100 E. Main Street
Certificate of Appropriateness HP24-000017

Request: Certificate of appropriateness (CofA) for:

Date of Review: January 21, 2024

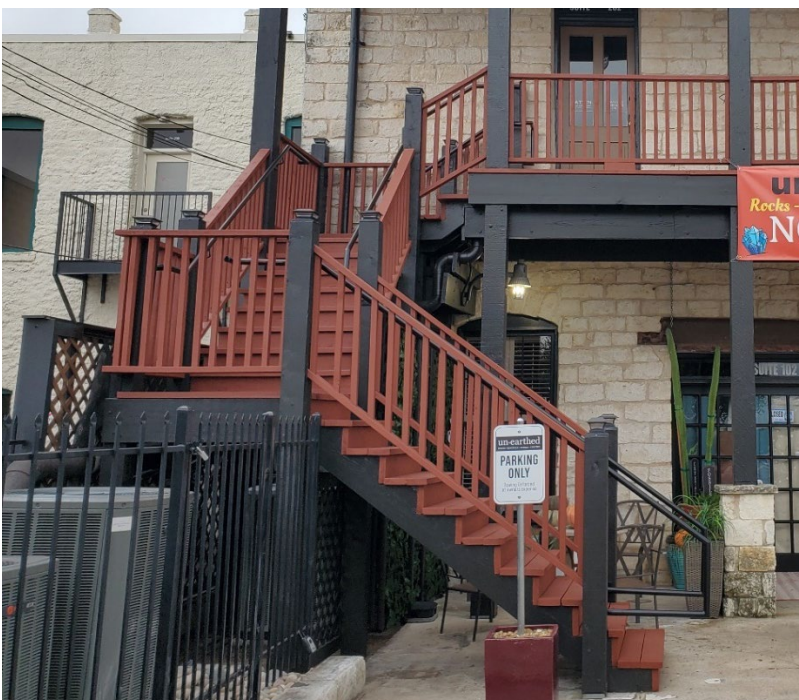
Part of this application concerns work noted in the 2024 tax exemption inspection that was completed without a CofA. The work included extensive repairs to the back porch, including replacing the back stairs. While repairs to the porch and walls are considered maintenance and do not require a CofA, there should have been one for the staircase because the configuration of the stair runs and landings was changed.

The previous back staircase was built in 1982 and is not considered to have attained its own historic significance. Previously the staircase had three landings and steps descending from the lowest landing both north and south. A back staircase is required by fire code to provide a second egress from the second floor.

The new back staircase eliminates the lowest landing, and a single flight continues west to grade level. The new staircase has the same type of construction with the same forms for posts, decking and railing. A new metal handrail and solar downlighting on the posts have also been added.

Standard for Rehabilitation #9 states that new additions to a should be compatible with the historic structure, and the Guidelines for new exterior additions recommend that new features should have a simple design and be secondary features to the historic structure. Staff agrees that the stair design meets this standard and that the new stair configuration is at least as appropriate for the building than the previous configuration. The THC also determined that the reconfigured stair is appropriate.

- The new staircase design is approved as presented.
- The standing seam metal roof is approved as presented.
- The illustrated light fixture is approved with the conditions that:
 - Light fixture may not be attached to the stone wall.
 - Applicant shall provide a product number and mounting location before ordering.
- Covering the I-beam lintel on the north wall is not approved.
 - If in the future an explanation for the different lintel types is presented, the HPC may reconsider the request without waiting a full year after denial.

Current light fixture (2022 photo)

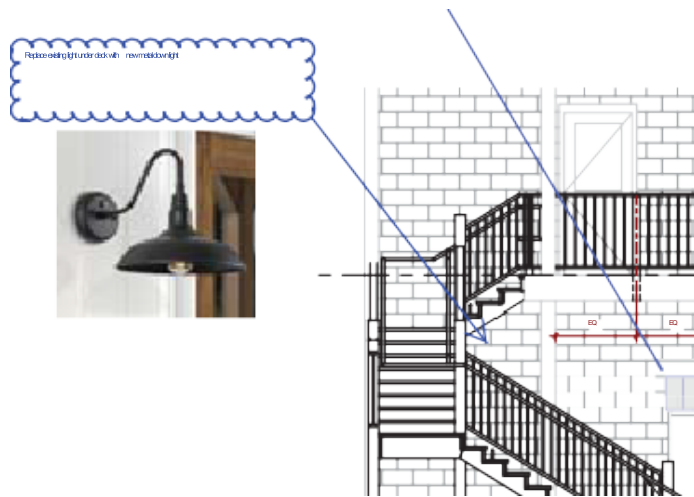
The applicant wishes to replace the light fixture under the staircase with one that is more period-appropriate. The application does not name a specific model for the new fixture but the photo in the plans show a black or dark bronze gooseneck light.

The THC agreed that the proposed fixture design is more appropriate but cautioned against installing one that was attached to the stone wall of the building. Staff believes the illustrated fixture is appropriate but would like to have the product number and specific location. Staff agrees that the fixture should be attached to the staircase rather than the stone wall.

Detail from application

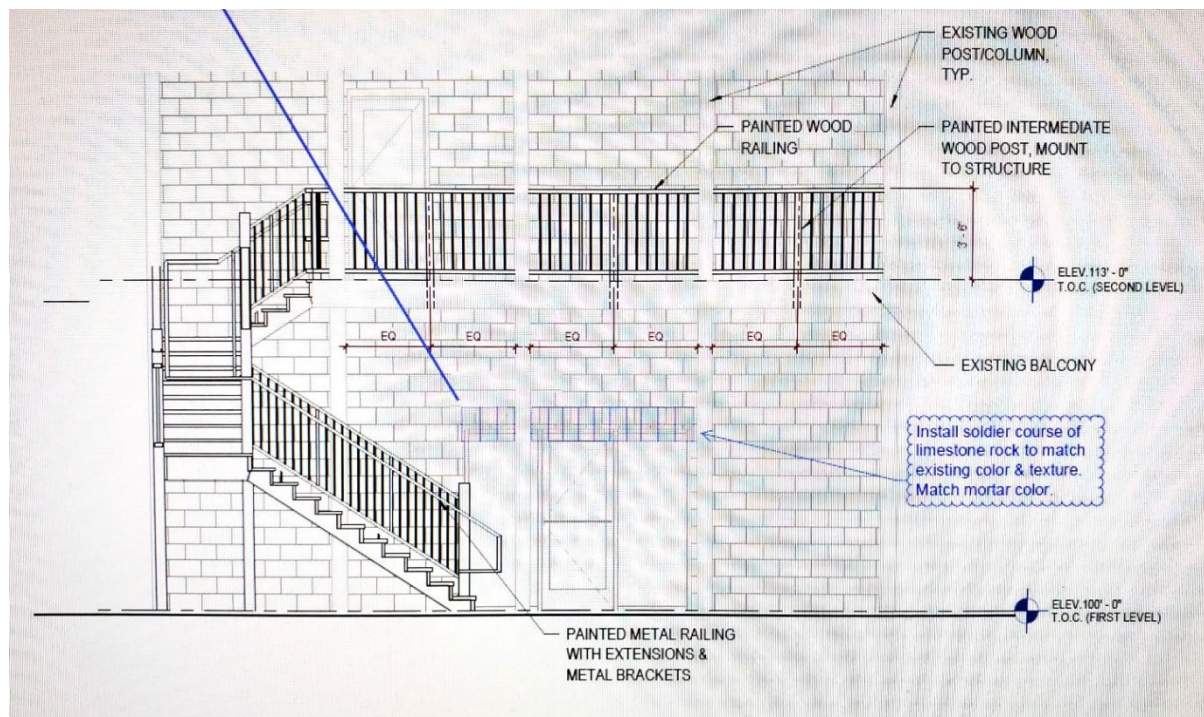
The fourth request is to cover a steel I-beam lintel in the north (back) wall with a soldier course of limestone veneer matching the color and texture of the stones in the wall. These stones would be hand-cut with chisel marks similar to the historic stone.

The THC determined that based on Standard for Rehabilitation #2, adding a soldier course of limestone veneer over the lintel would create a false sense of development. They denied the request, recommending that the lintel remain exposed as evidence of the period when the vehicle entrances were added. The applicant has noted the tenants do not like the rusty appearance of the lintel.

It's possible that the different lintel types reflect different eras of the building's history, and it's also possible that the era embodied in the I-beam lintel is as significant as the era evidenced by the steel plate lintel. Staff attempted to contact the architect who managed the 1982 rehabilitation but was unsuccessful. Until the different lintel types is explained staff also recommends against covering the I-beam lintel on the back wall.
